TR Number	19-16
Primary Reference	GMA G-192-5
Purpose	Confirm conflict between Appendix G-192-5 and B31.8 Appendix I and take appropriate action.
Origin/Rationale	<p>Stephen Beatty email 2/4/19</p> <p>(1) It appears that there is a slight discrepancy between the Figure 192.235C(5) and ASME B31.8 Appendix I Figure I-6 (c).</p> <p>(2) If Figure 192.235C(6) is intended to match ASME B31.8 Appendix I-3.1, it may need to be updated.</p> <p>If edits are made to this appendix, there are some slight font size inconsistencies that may be desirable to change at the same time</p>
Assigned to	Design TG

GMA G-192-5

Sleeve Type Joint
(6)

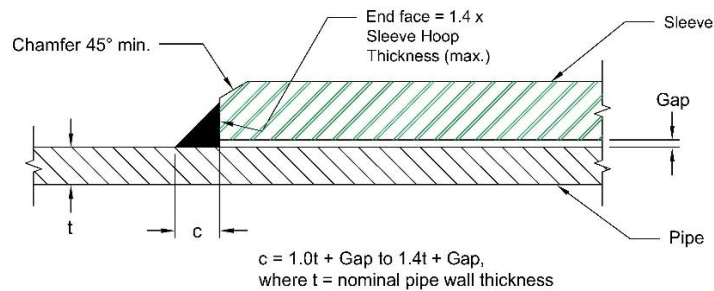
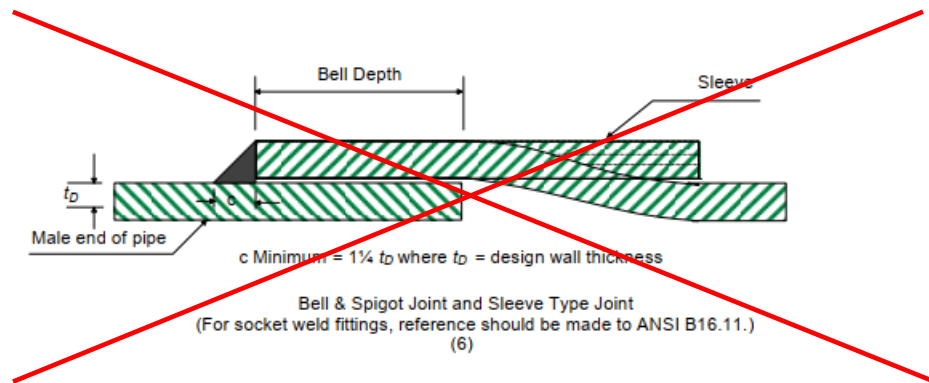
[Editorial Note: FIGURE 192.235C has 8 drawings labeled (1) – (8). The drawing labeled (6) should be deleted and replaced with a different drawing as shown below.]
